TRAFFIC CONTROL PLAN

Bridge Replacement in town of Burke, VT
BRF 0269(13)

SHOP DRAWING REVIEW

☐ REJECTED ☒ REVISE AND RESUBMIT ☐ APPROVED AS NOTED

PROJECT NAME: BURKE	
PROJECT NUMBER: BRF 0269(13)	
FILE NAME: 10c412/cos/z10c412bdrtcp.dgn	PLOT DATE: 11/19/2014
PROJECT LEADER: J. BYATT	DRAWN BY: M. HALEY
DESIGNED BY: M. HALEY	CHECKED BY: P. SHEDD
TRAFFIC CONTROL SHEET	SHEET 20 OF 73

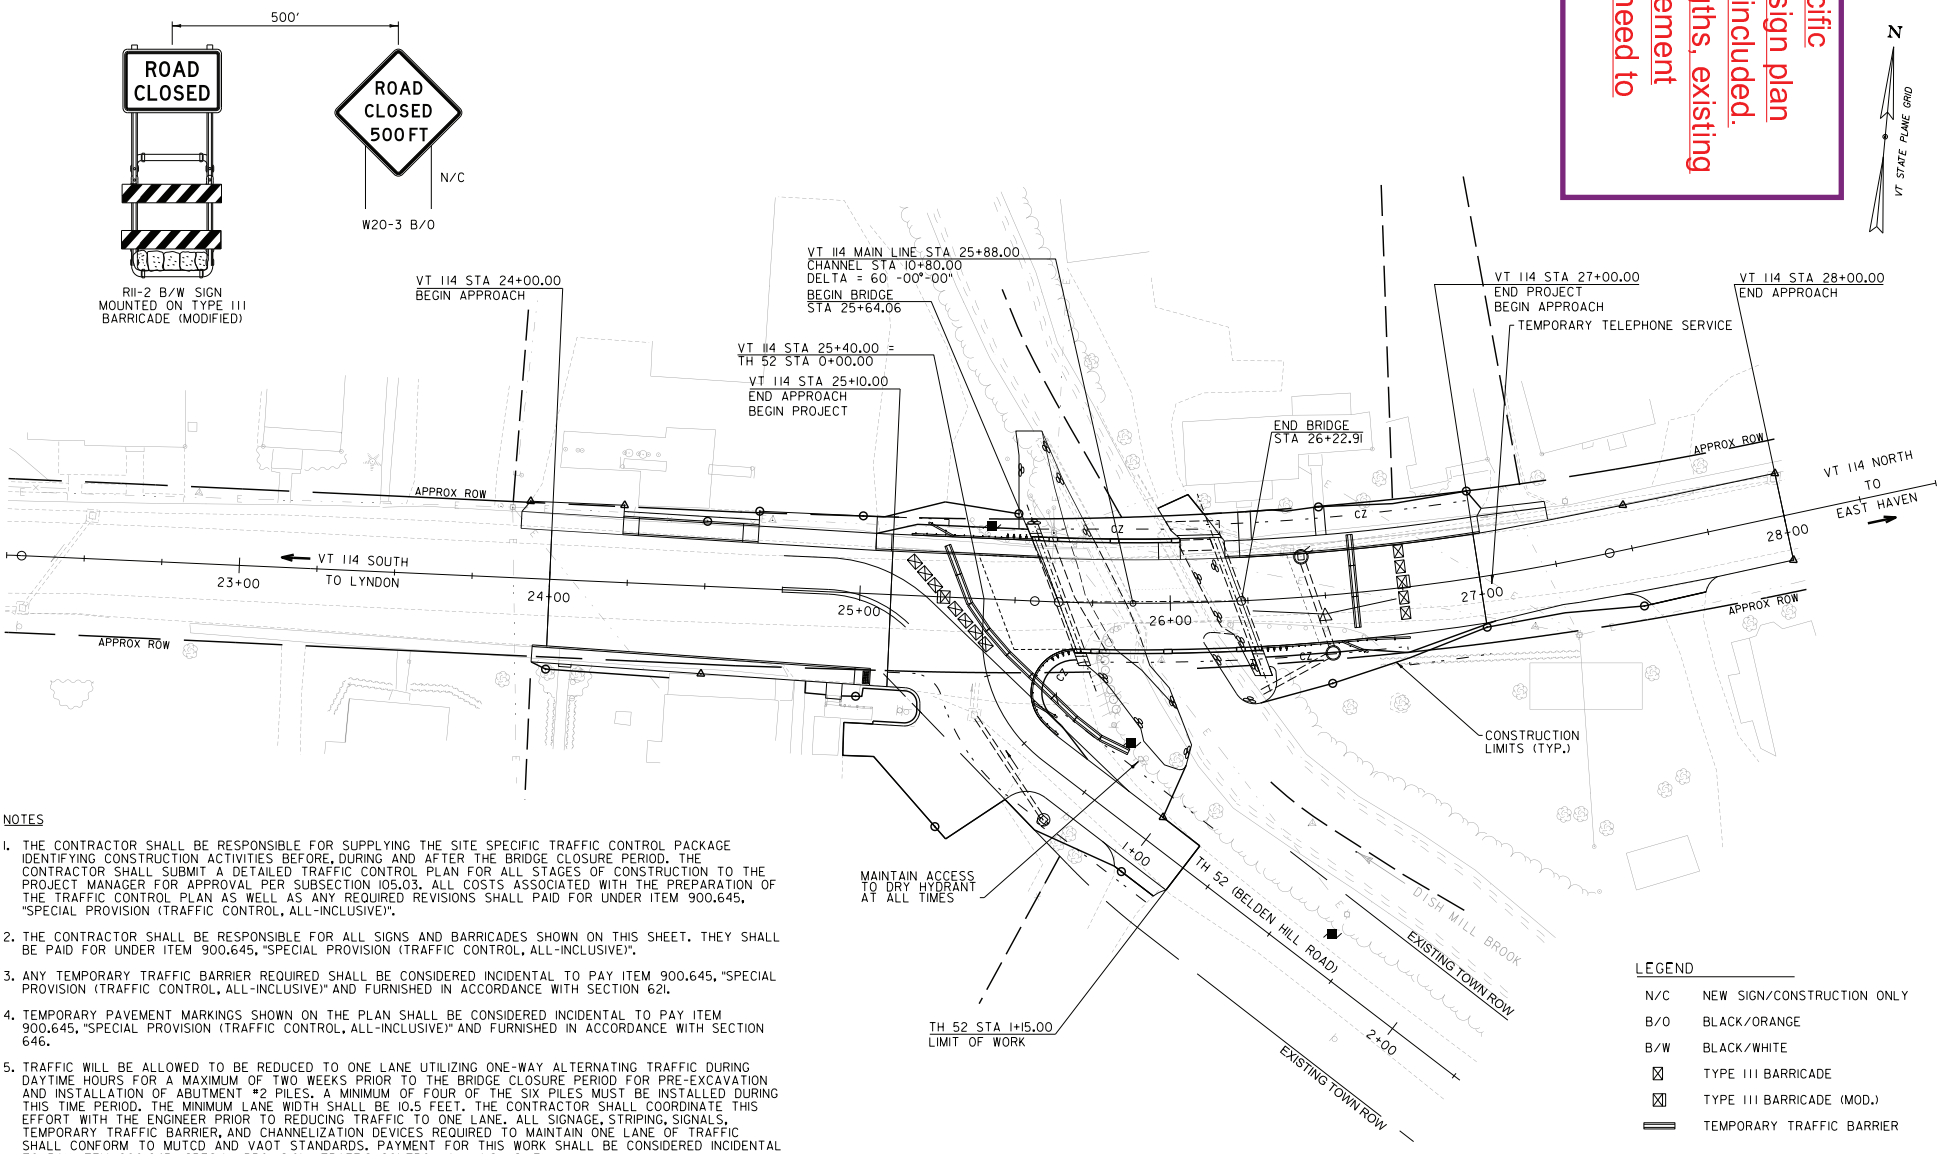
A site specific approach sign plan should be included. Taper lengths, existing signs, pavement markings need to specified.

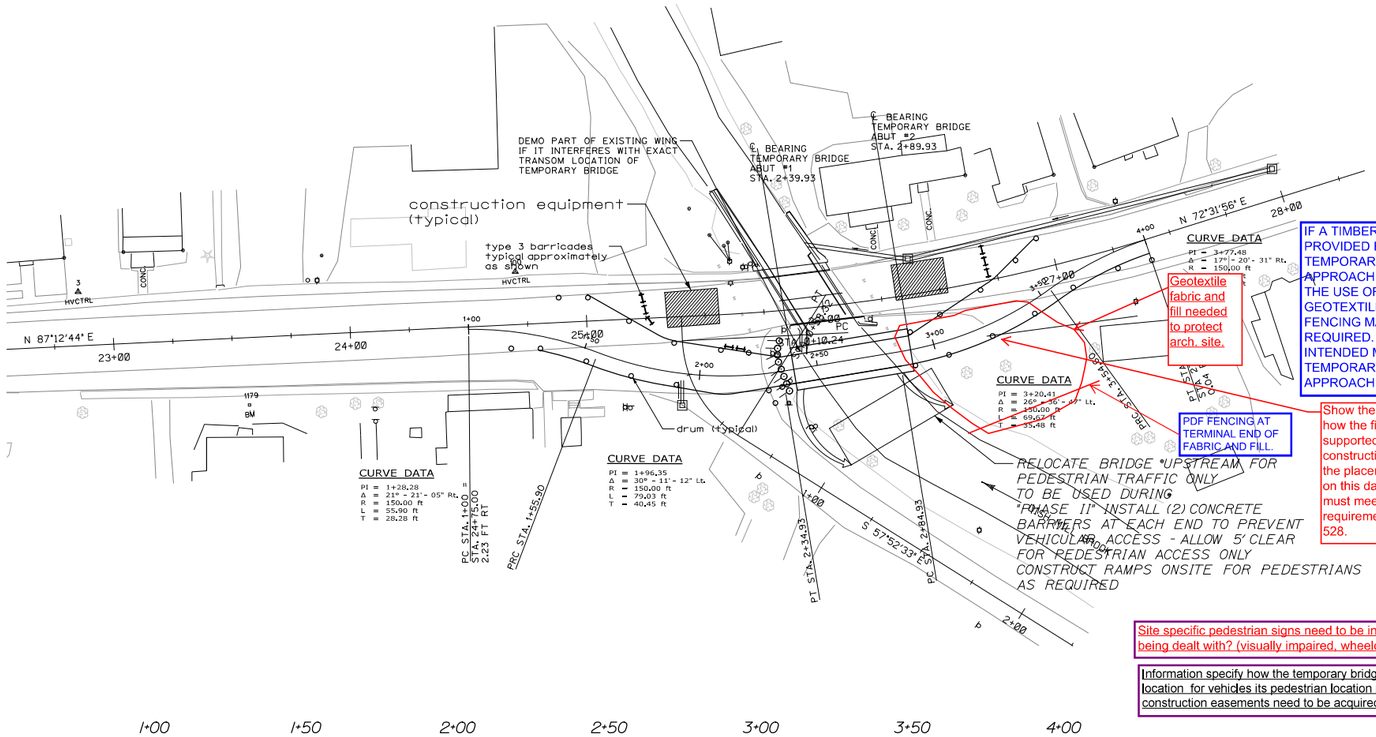
IF A TIMBER RAMP IS PROVIDED FOR THE TEMPORARY BRIDGE APPROACH RATHER THAN THE USE OF FILL, GEOTEXTILE AND/OR PDF FENCING MAY NOT BE REQUIRED. SHOW THE INTENDED METHOD OF TEMPORARY BRIDGE APPROACH ON PLAN.

Geotextile fabric and fill needed to protect arch. site.

PDF FENCING AT TERMINAL END OF FABRIC AND FILL.

Show the toe of slope or how the fill will be supported to stay in the construction limits. With the placement of all traffic on this daytime detour it must meet the requirements of section 528.

Site specific pedestrian signs need to be indicated. How are ADA provisions being dealt with? (visually impaired, wheelchair access, etc.?

Information specify how the temporary bridge will be moved from it's lane detour location for vehicles its pedestrian location needs to be addressed. Will additional construction easements need to be acquired? ROW? Other impacts?

STANDARD

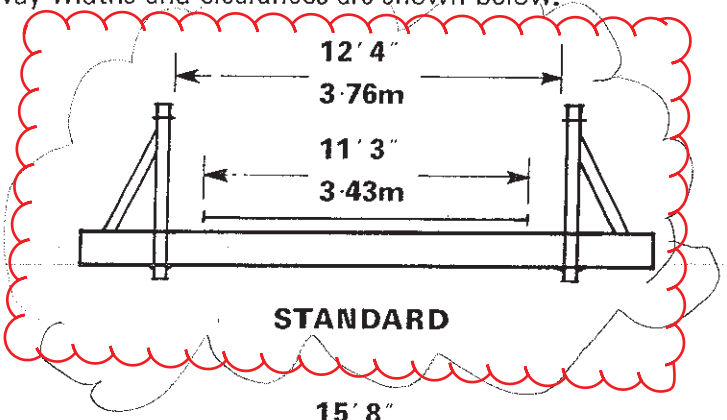
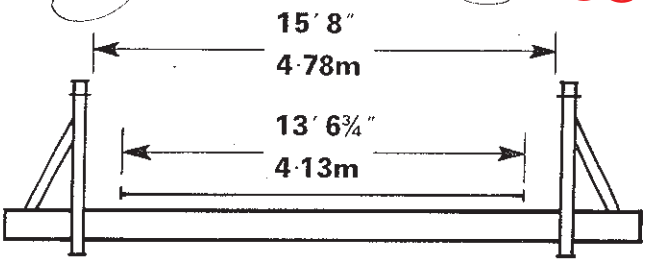
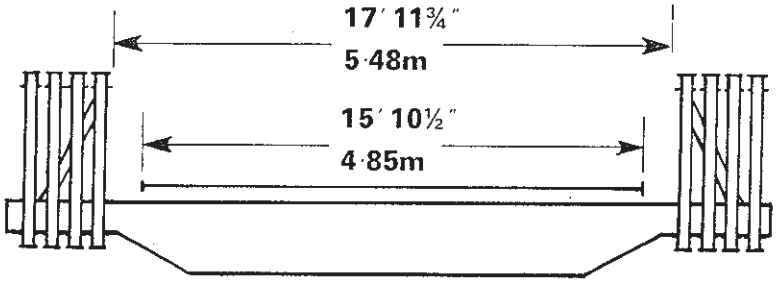
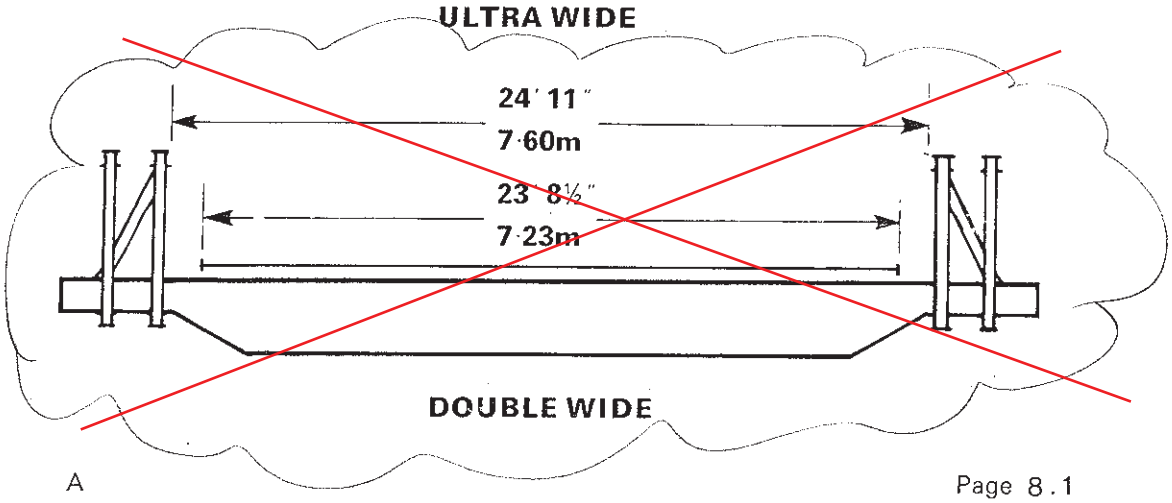
GIVEN THE NARROW WIDTH OF THE TEMPORARY BRIDGE, PLEASE CHECK THE TURNING RADII OF LARGER VEHICLES ALONG THE TEMPORARY BRIDGE ALIGNMENT TO ENSURE THEY WILL BE ABLE TO ACCESS THE BRIDGE WITHOUT HITTING THE RAIL.
